**SUBJECT:** ZMAP 2006-0025, SPEX 2006-0031  
Cascades Center, 1<sup>st</sup> Referral

**SUBJECT:** ZMAP 2006-0025, SPEX 2006-0031  
Cascades Center, 2<sup>nd</sup> Referral

DATE: June 15, 2007  
TO: Stephen Gardner, Project Manager, Planning Division  
THRU: Marilee L. Seigfried, Deputy Zoning Administrator  
FROM: Diane B. Ferrall, AICP, CZA, PRS-ESI  
RE: Cascades Center ZMAP-2006-0024/SPEX-2006-0031 – 2nd SUBMISSION

**DATE:** January 9, 2007  
**TO:** Stephen Gardner, Project Manager, Department of Planning  
**FROM:** Art Smith, Senior Coordinator, Planning and Development   
**SUBJECT:** ZMAP 2006-0025 and SPEX 2006-0031 - Cascades Center  
First Referral

#### PROPOSED LANDSCAPE PLAN

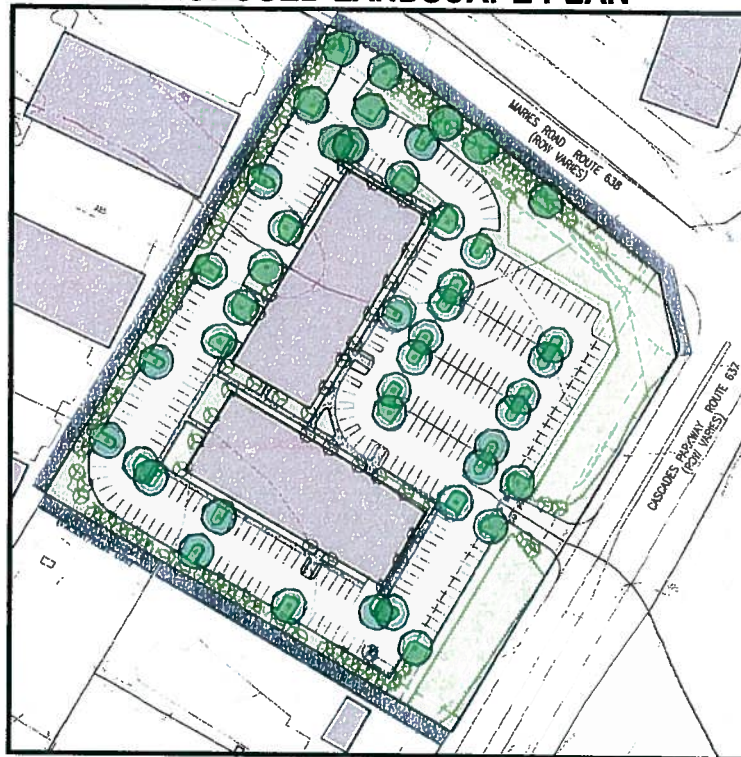
***Staff recommends that the project area include high-quality architectural features and enhanced landscape areas per Plan policy. The applicant should provide illustratives of the intended architectural features and describe the materials to be used. The applicant should also describe how landscape features and materials will be integrated into the design.***

***Staff recommends that parking be placed behind buildings in conformance with Plan policies. Any parking structures should exhibit a high architectural quality and be placed behind the buildings. The applicant should also consider gateways, walls, or other design elements along both street frontages, along with enhanced landscape plantings.***

AM and PM Peak Hour Volumes  
 Total Conditions Alternative A

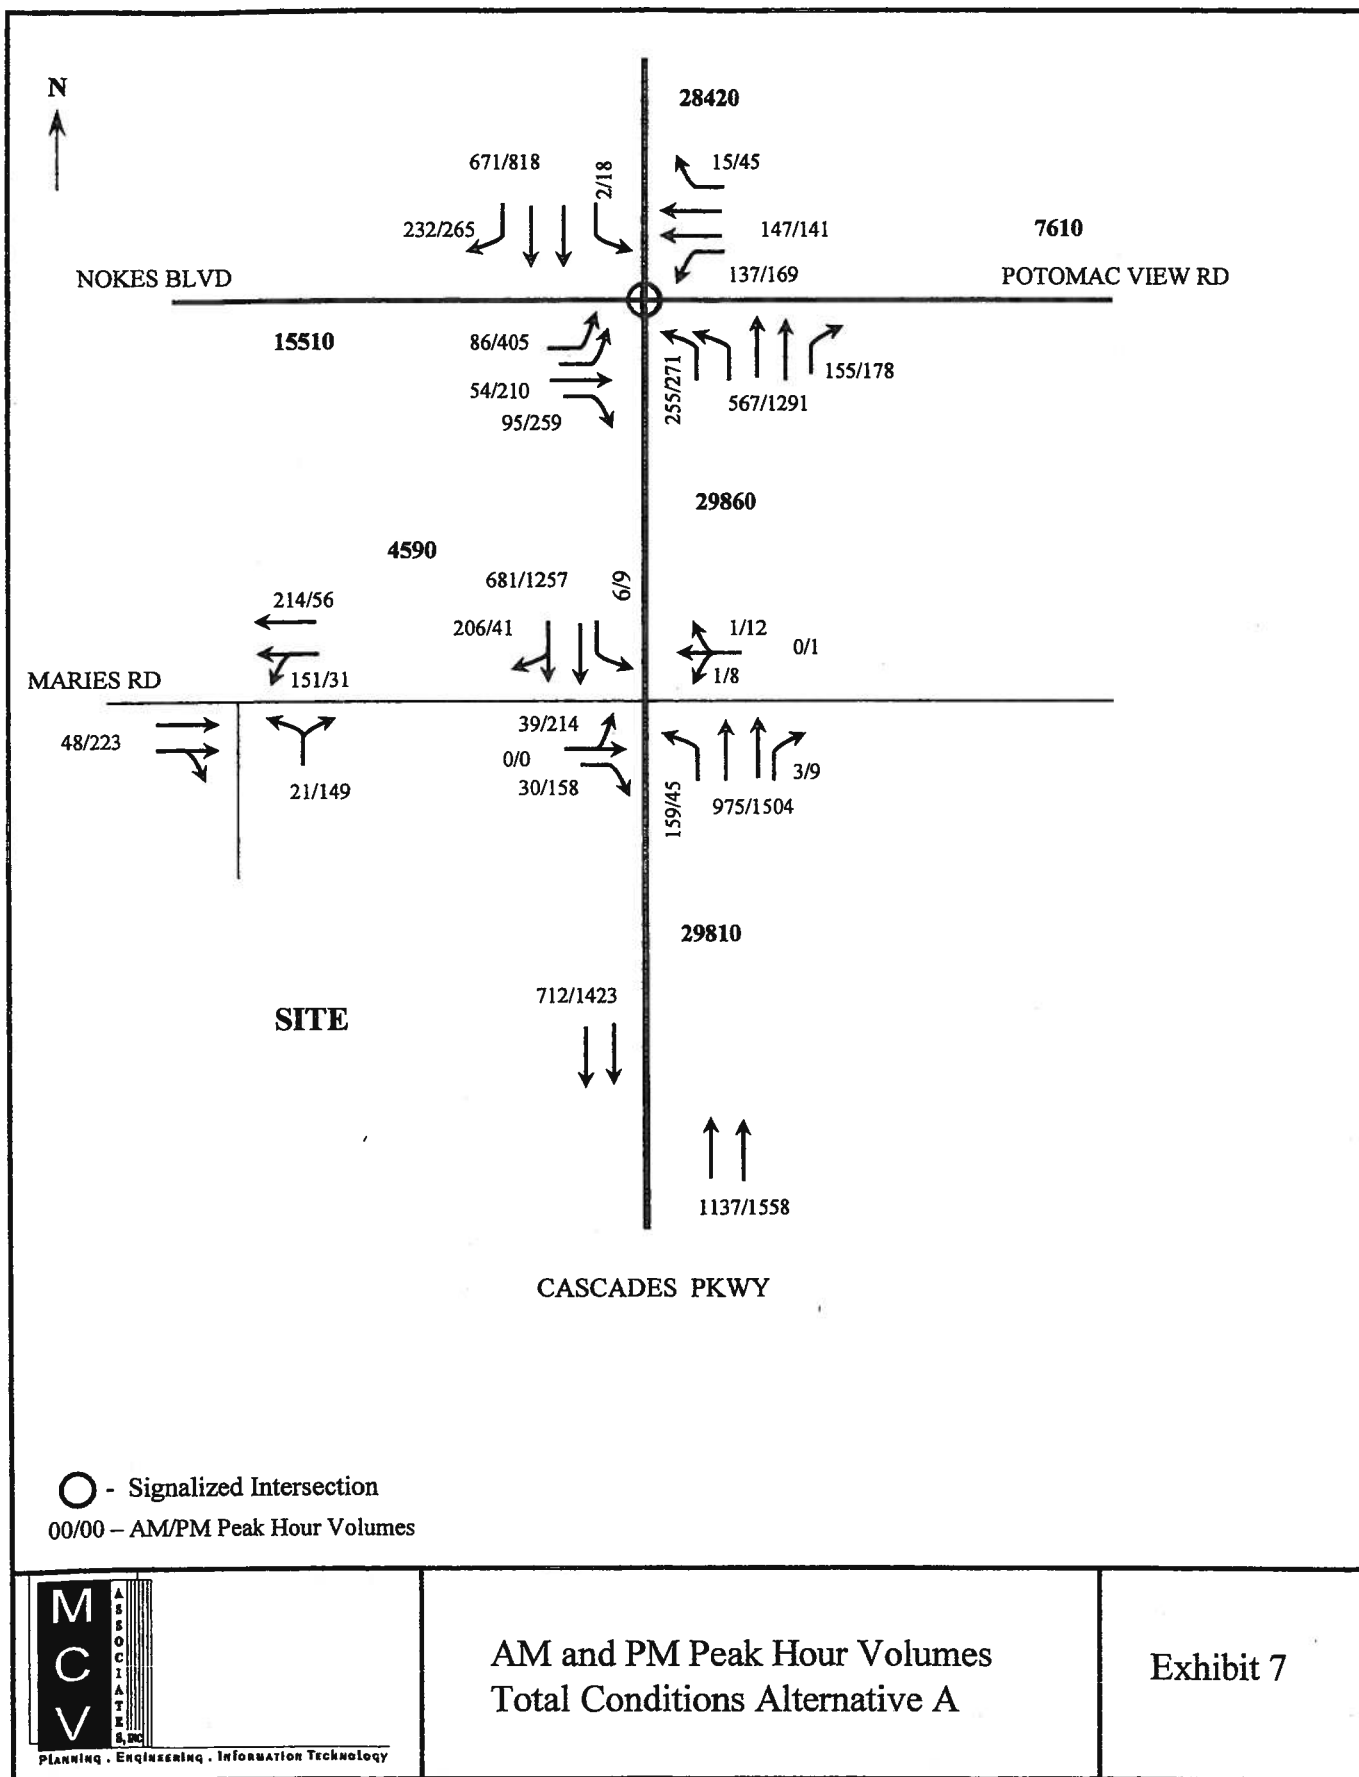
1. The Countywide Transportation Plan (CTP) calls for Cascades Parkway to be a controlled access road. That policy prohibits a right in/right out entrance to a single lot. Therefore, Alternate A, access only by Maries Road only, should be implemented.

**Figure 2: Claude Moore Park directional sign on southbound Cascades Parkway to be revised with the installation of a new traffic signal**

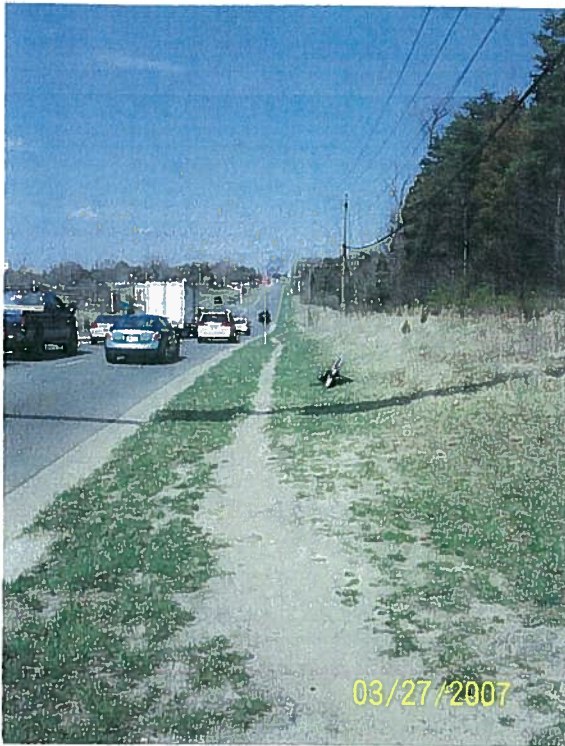
7. In addition to Comment 6, when the traffic signal is installed at the intersection of Cascades Parkway, Maries Road, and the entrance to the Claude Moore Park Visitor Center, it will alter existing park directional signage along southbound Cascades Parkway. Currently, the sign references the entrance to the active portion of the park at the "second traffic light" (see *Figure 2*). When the additional signal is added, PRCS requests the Applicant to provide the funding for revising the existing sign or provide a revised sign.
